Economic Development Queensland

PRE2024/845 – Homestead Drive, Monarch Glen

RAL for 582 Residential Lots, Park and Road and Associated PoD forming Precincts 101 and 102 of Monarch Glen Masterplan

PRE2023/689 ([F23/4733](#)) Undullah Due Diligence

CONCEPT PLAN

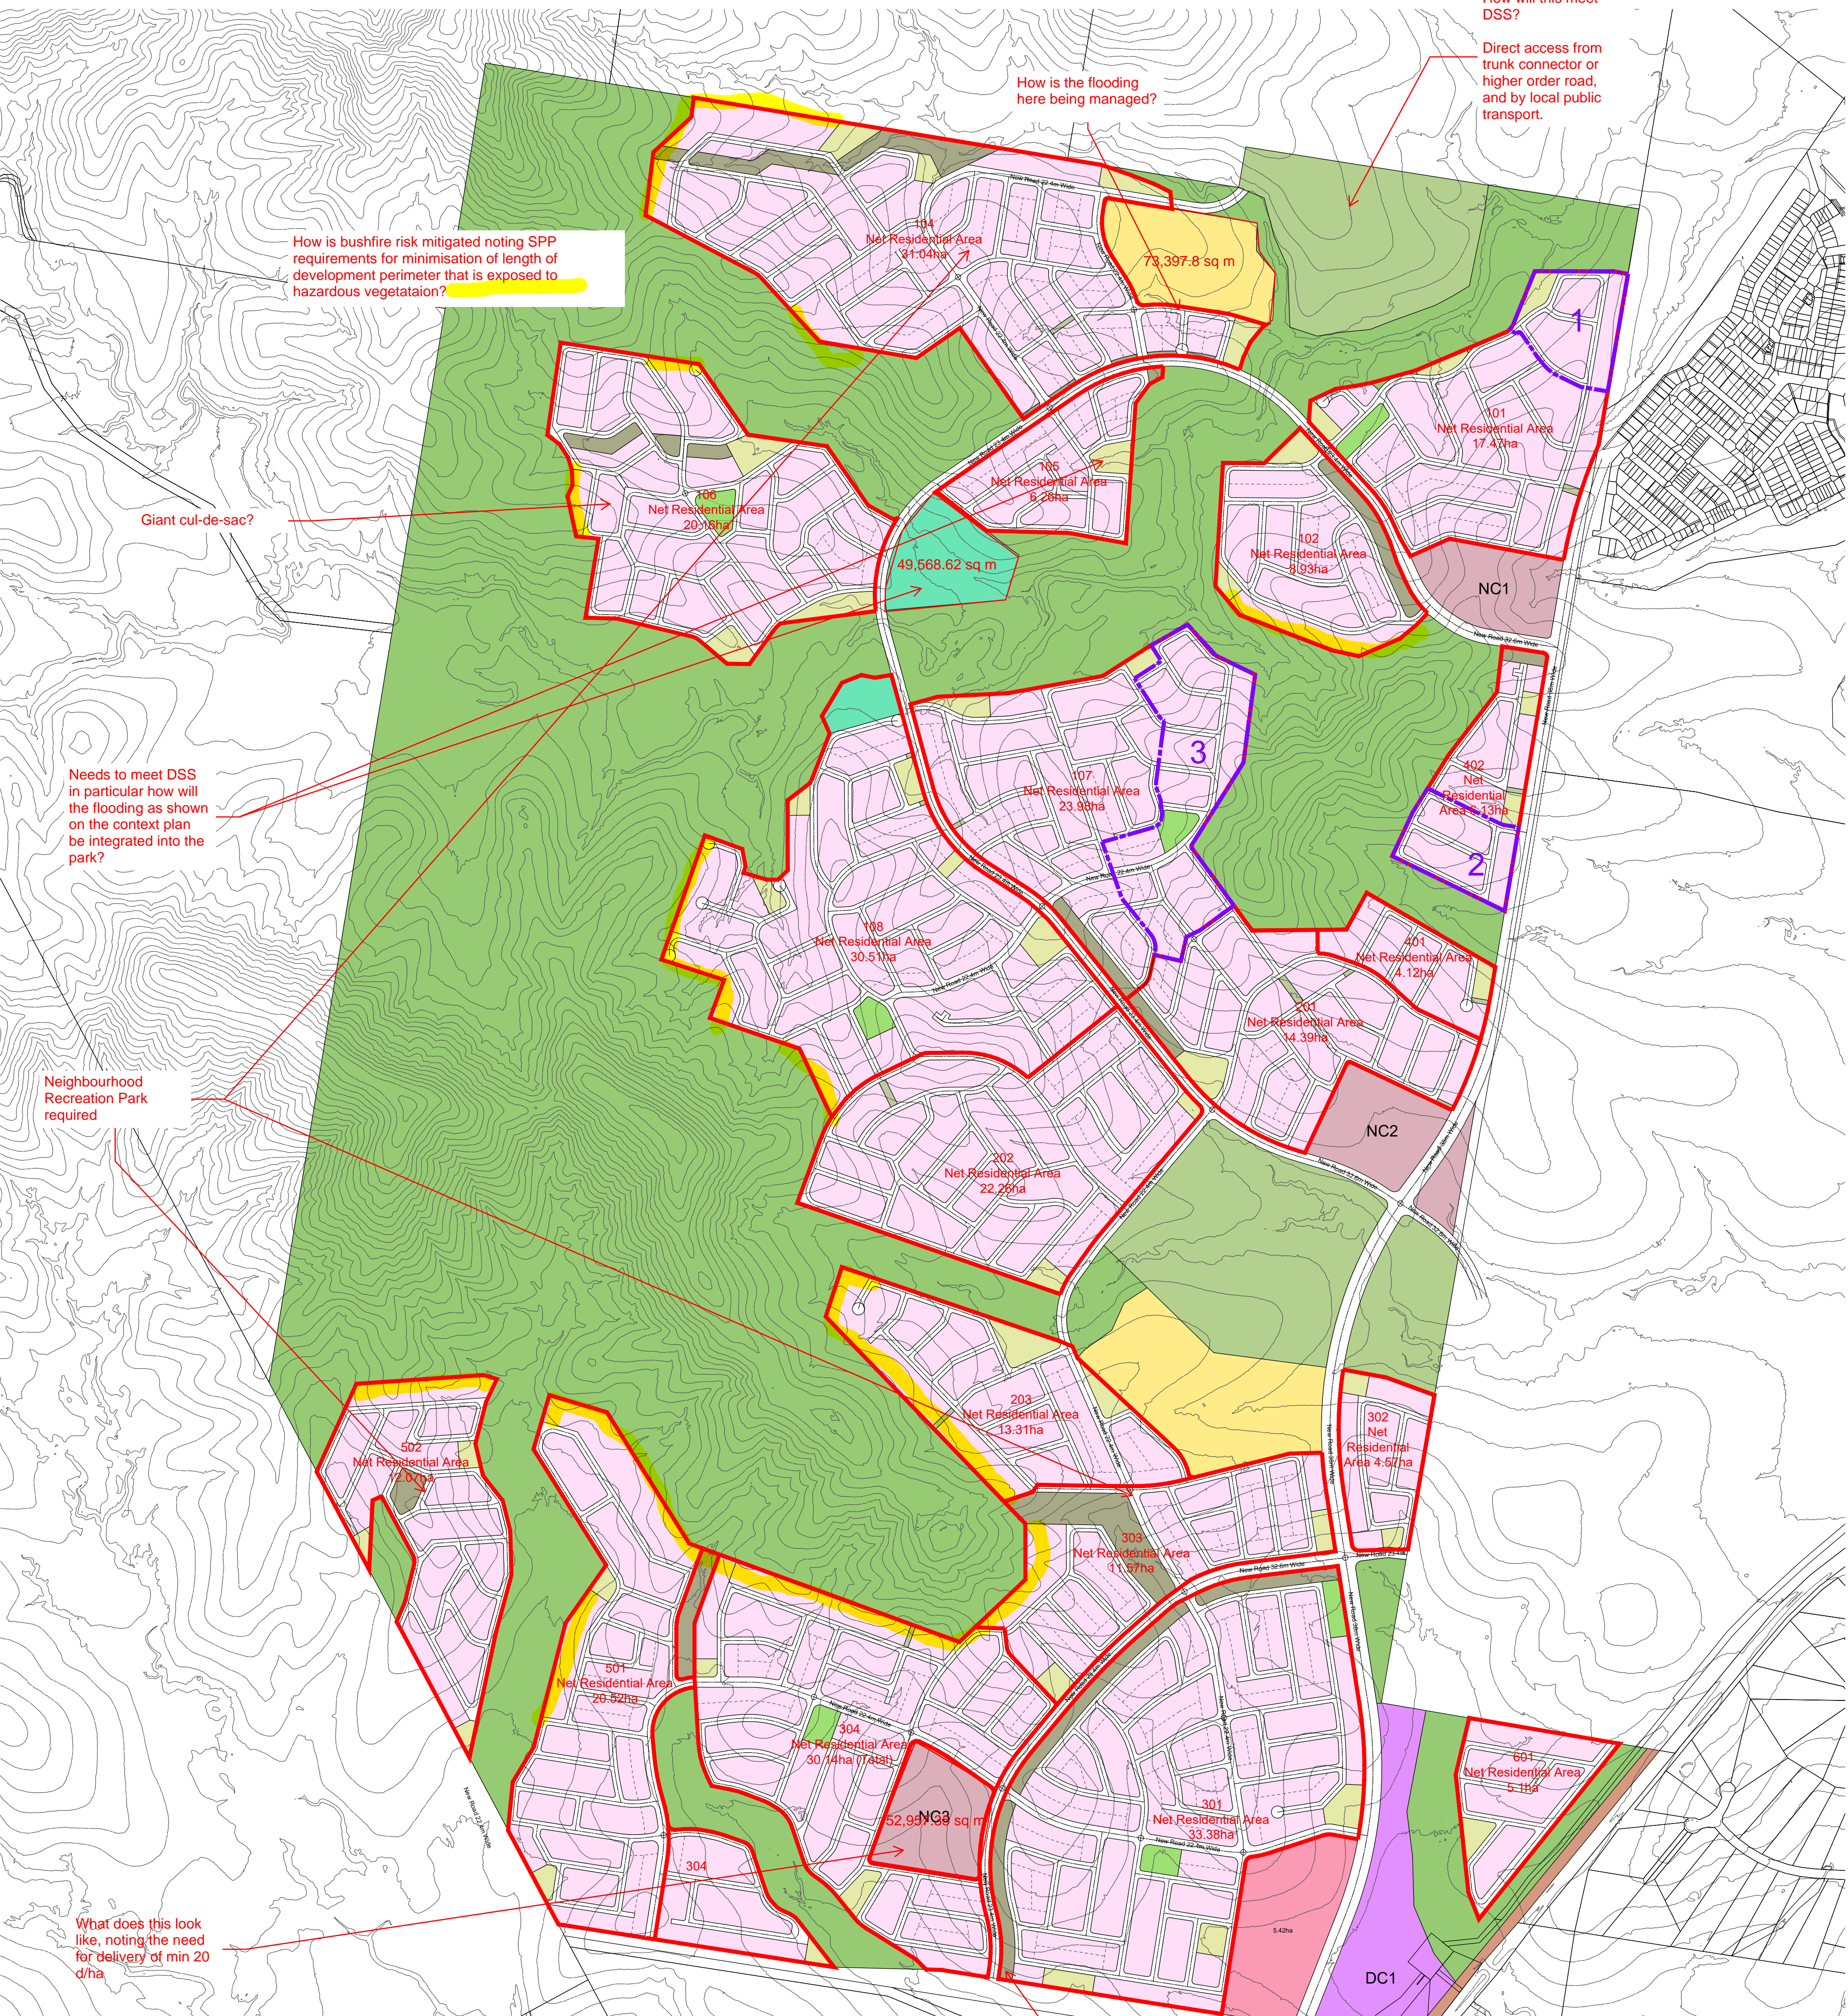
- ***Provide comments on the preliminary concept plan provided as attachment A***
See attached, marked-up plan.
